IN THE UNITED STATES PATENT AND TRADEMARK OFFICE

Applicants : Koellner et al.
Serial No. : 10/562,172
Filed : December 21, 2005
For : Door Module
Group Art Unit : 3634
Confirmation No. : 1304
Examiner : Gregory J. Strimbu

AMENDMENT UNDER C.F.R. § 1.116

Fig. 2b

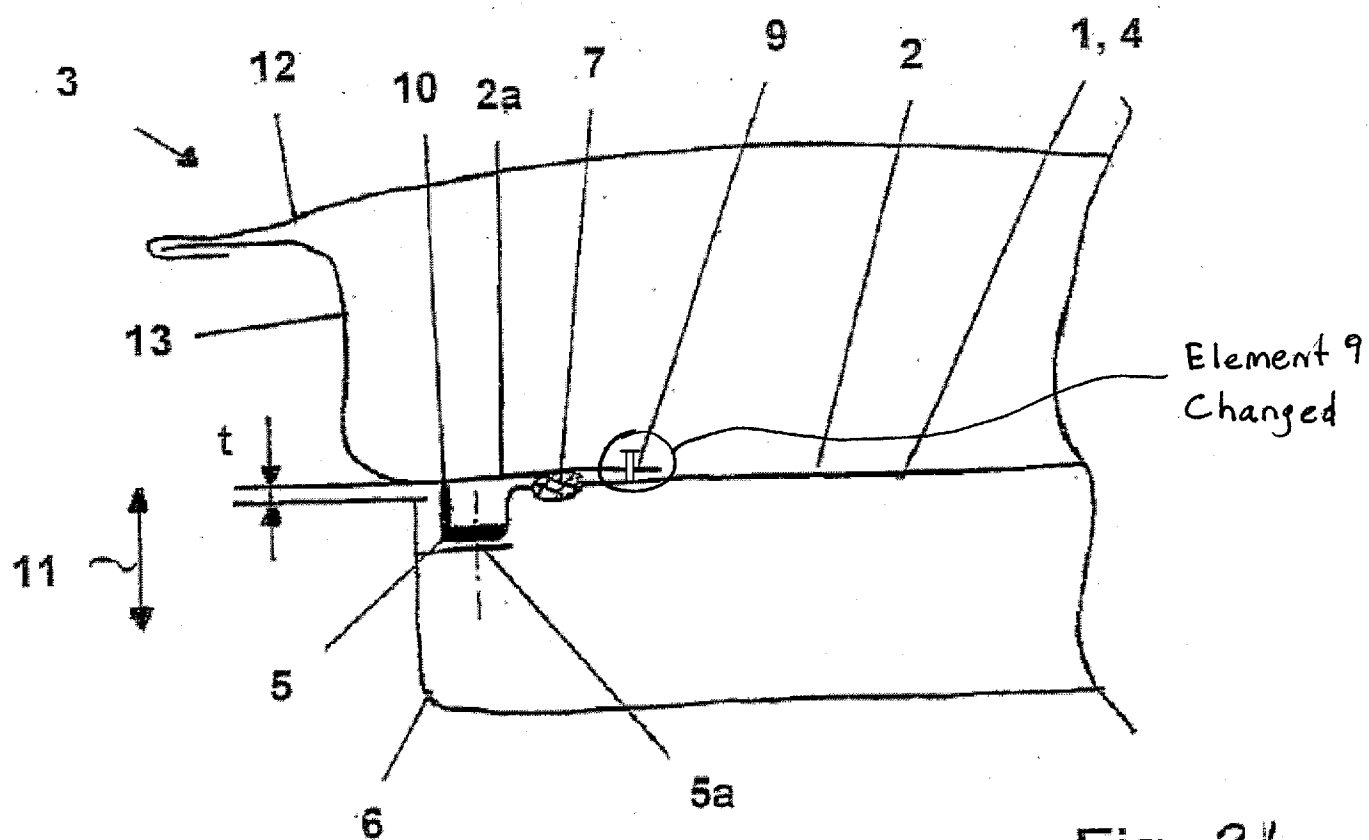
The attached sheet of drawings contains changes to Figure 2b. This figure, which contains Figures 2a and 2b, replaces the original sheet containing these drawings. In Figure 2b, element 9 has been changed for the purpose of clarity.

The drawings stand objected to because it is unclear how, in Figure 2b, element 9 represents a locking lug 9. In view of the amendment to the drawings, Applicants respectfully request the withdrawal of this objection.
